PLANS AND DOCUMENTS
referred to in the PDA
DEVELOPMENT APPROVAL

Approval no: DEV-2026-CAS-4471

WASTE MANAGEMENT PLAN

LOT 8006 ON SP357729, SUB-PRECINCT 10.1, Nirimba

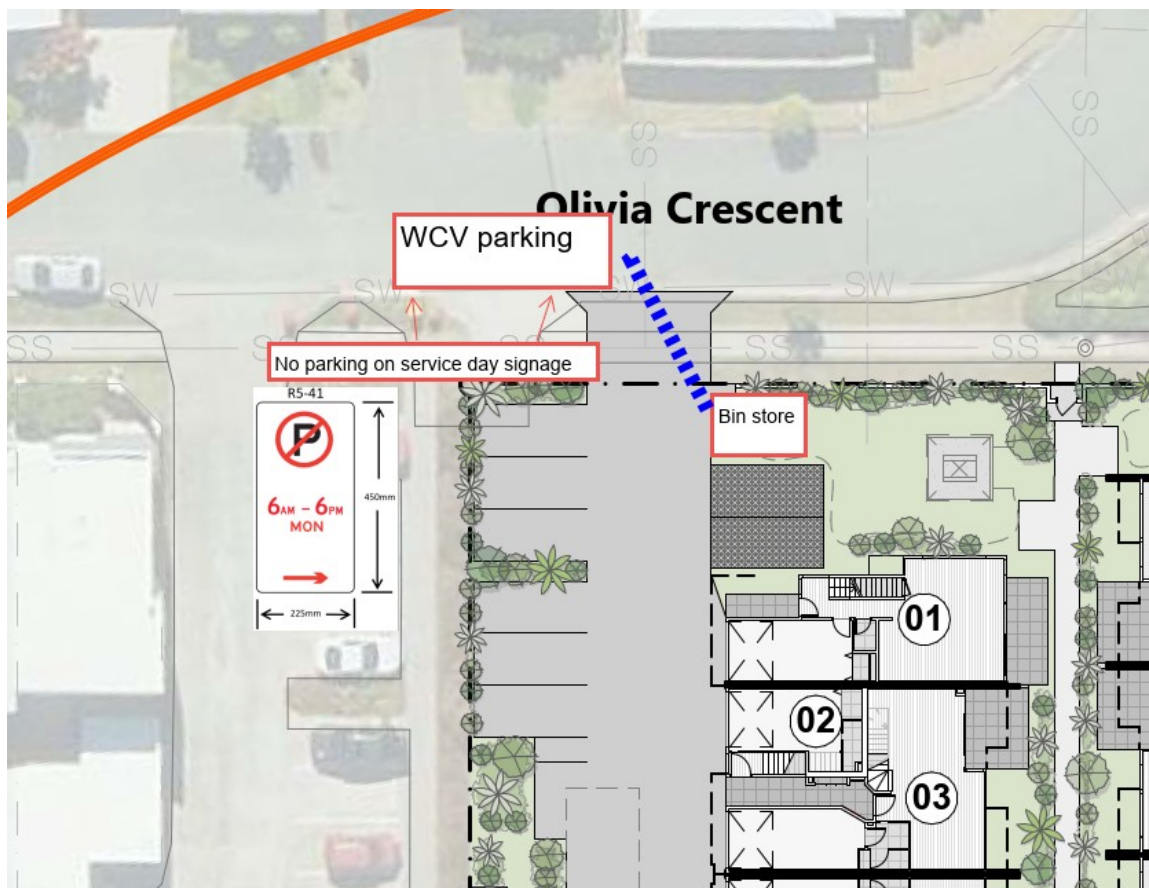
Thanks for your query. In response to your questions, I can confirm that 80L waste generation rate for 1 & 2 bedroom apartments would be acceptable to SCC and has been accepted previously.

In relation to waste servicing the option proposed could work however I have some concerns and also have an alternative which would be more in line with AO4.3 of the Waste management code. The proposed location would mean the rear lift WCV would have to navigate through the adjoining laneway which could create additional impacts to these dwellings which are currently serviced by the side lift truck. The truck will park right next to the end dwelling in the lane for a period of time which will also impact upon their amenity. The parking location will also block cars parked in the adjacent bays causing conflict with the WCV.

I would suggest that a service at the kerbside of Olivia Crescent would be more efficient and create less conflicts. Would also remove the need for additional pathways and loss of landscape. The bin store could be located in an expanded bin store next to visitor bay 7. The bin store could be a permanent store and freeing up space elsewhere and reducing the need for management to move bins to a temp location. Signage could be provided on Olivia Crescent just to the west of the driveway to prevent parking on service day (location and example signage shown). Have marked up a plan showing my suggestion.
